WLD4 - Replacing Hose for Positive Crankcase Ventilation (Workshop Campaign)

Model Line: **Panamera (971)**

Subject: **Positive crankcase ventilation hose**

Installation location for positive crankcase ventilation hose.

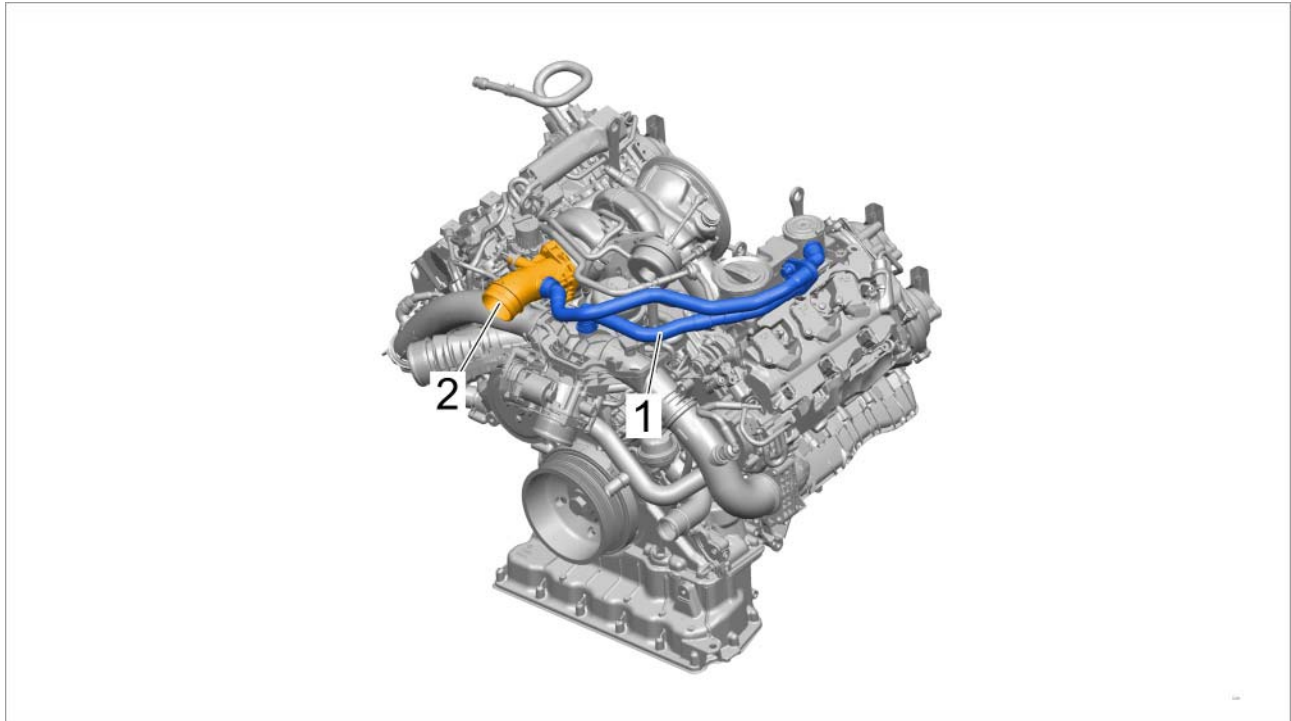
Information: **A part-load valve was installed in the hose for crankcase ventilation on the affected vehicles which has a sealing washer that does not meet the required specifications and could possibly crack when the crankcase pressure rises.**

Consequently, small amounts of engine oil can leak from the oil filler cover into the adjacent engine compartment, resulting in a reduced engine oil level over time. The driver is alerted by an appropriate warning message if the engine oil level is too low.

Remedial Action: Replace positive crankcase ventilation hose.

Installation location for positive crankcase ventilation hose.

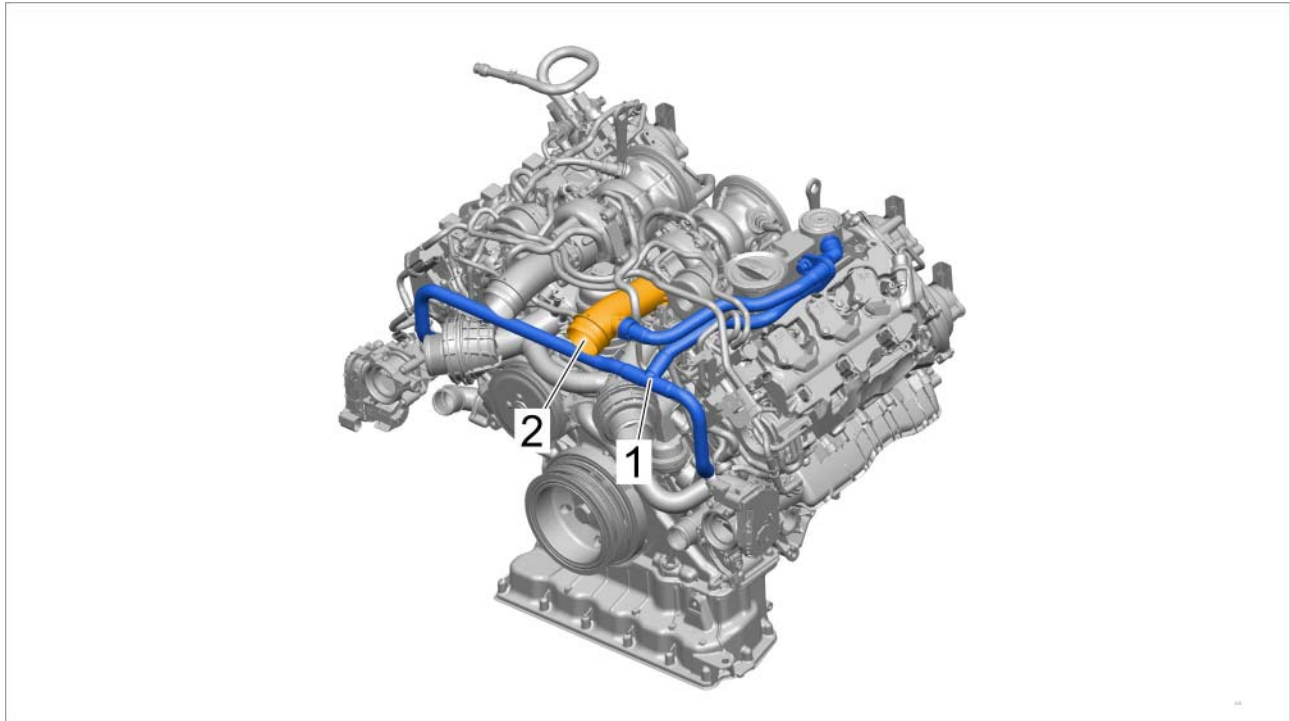
Information: **A part-load valve was installed in the hose for crankcase ventilation on the affected vehicles which has a sealing washer that does not meet the required specifications and could possibly crack when the crankcase pressure rises.**

Consequently, small amounts of engine oil can leak from the oil filler cover into the adjacent engine compartment, resulting in a reduced engine oil level over time. The driver is alerted by an appropriate warning message if the engine oil level is too low.

Remedial Action: Replace positive crankcase ventilation hose.

Detaching hose

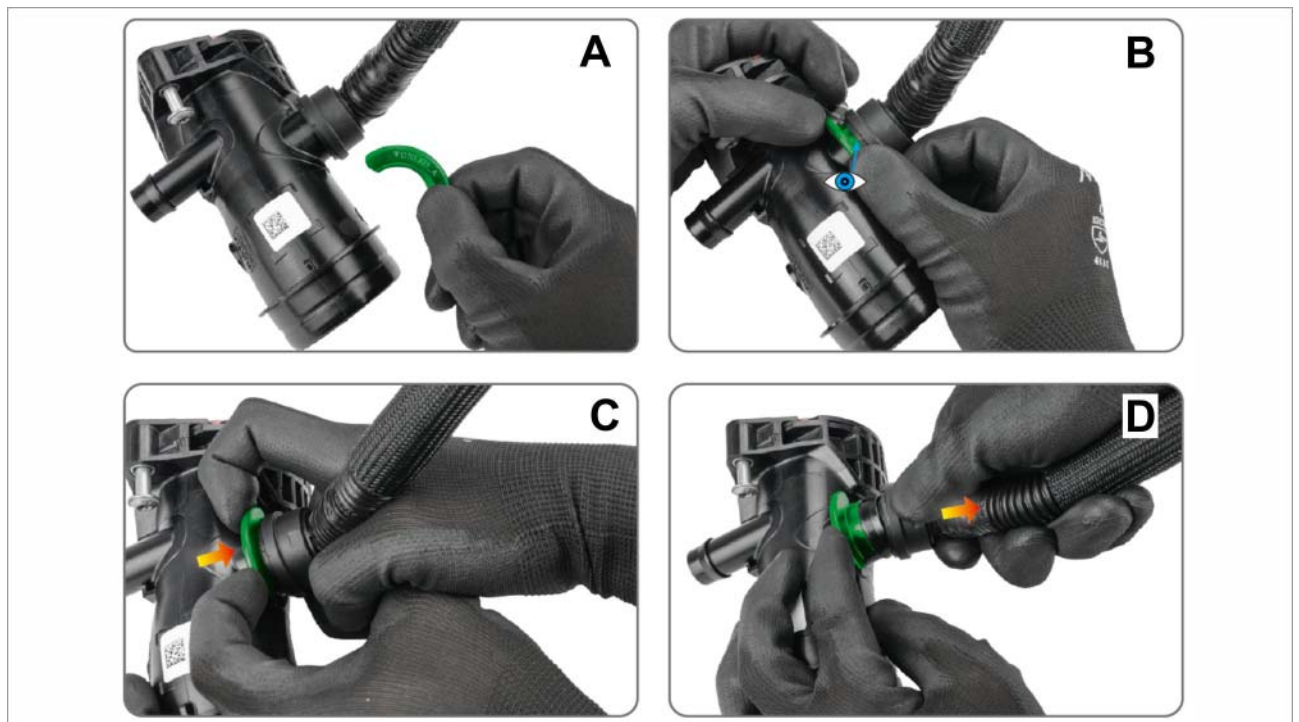
- 2 Remove positive crankcase ventilation hose.
 - 2.1 Press release buttons on both sides and loosen adapters on oil mist separator ⇒ *Detaching hose -1-* and positive crankcase ventilation system ⇒ *Detaching hose -2-*.
 - 2.2 Press release buttons on both sides and loosen pressure pipe adapter ⇒ *Detaching hose -4-*.
 - 2.3 Disconnect intake manifold adapter ⇒ *Detaching hose -3-*.

- 2.3.1 **Release tool CT0.J01_A** should be inserted into the separation point between the intake manifold and the hose ⇒ *Disconnecting hose -A-* and checked for proper seating ⇒ *Disconnecting hose -B-*.
 - 2.3.2 Push the release tool in the direction of the arrow ⇒ *Disconnecting hose -C-* and pull the hose out of the intake manifold ⇒ *Disconnecting hose -D-*.
- 3 Insert a new crankcase ventilation hose at the separation points in reverse order and check for correct seating.

Detaching hose

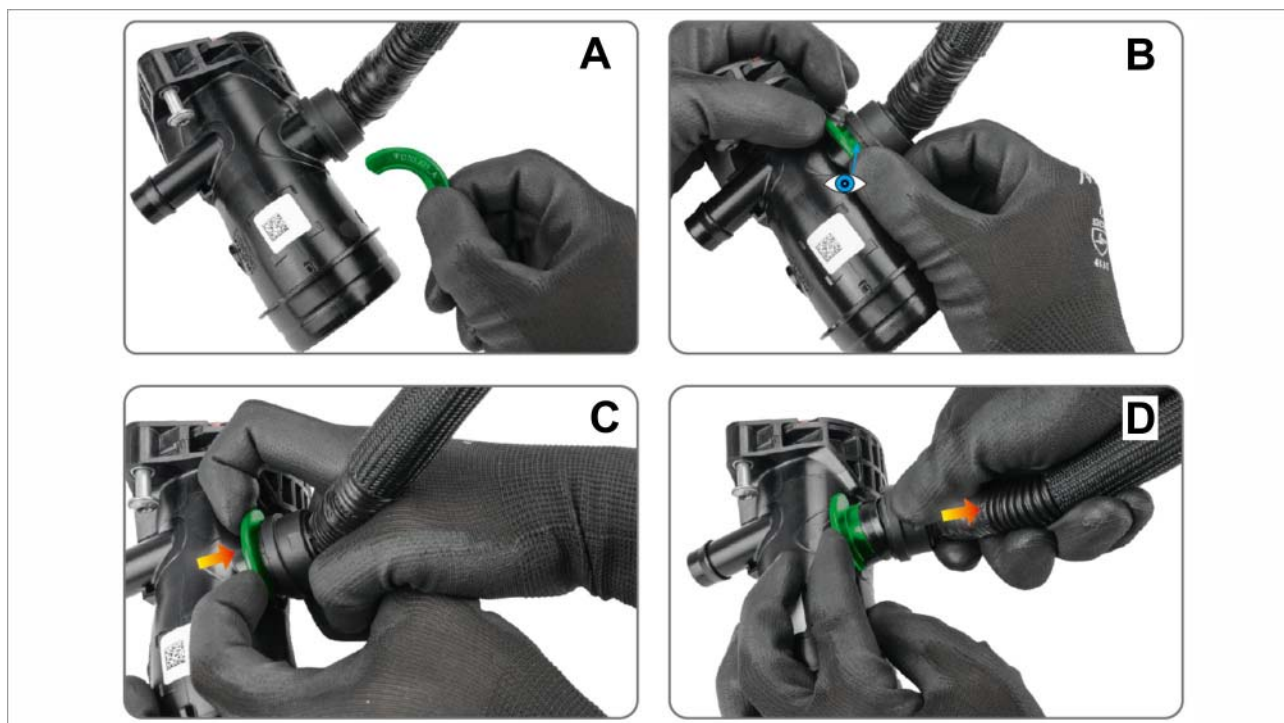
- 3 Remove positive crankcase ventilation hose.
 - 3.1 Press release buttons on both sides and loosen adapters on oil mist separator ⇒ *Detaching hose -2-* and positive crankcase ventilation system ⇒ *Detaching hose -1-*.
 - 3.2 Loosen the hose on the cable holders.
 - 3.3 Press release buttons on both sides and pull the hose off the intake air distributor on the left ⇒ *Detaching hose -3-* and right ⇒ *Detaching hose -4-*.
 - 3.4 Do not disconnect intake manifold adapter.

- 3.4.1 **Release tool CT0.J01_A** should be inserted into the separation point between the intake manifold and the hose ⇒ *Disconnecting hose -A -* and checked for proper seating ⇒ *Disconnecting hose -B -*.
 - 3.4.2 Push the release tool in the direction of the arrow ⇒ *Disconnecting hose -C -* and pull the hose out of the intake manifold ⇒ *Disconnecting hose -D-*.
- 4 Insert a new crankcase ventilation hose at the separation points in reverse order and check for correct seating.

Tighten the screw-type clamp. **Tightening torque 3.5 Nm (2.5 ftlb.)**
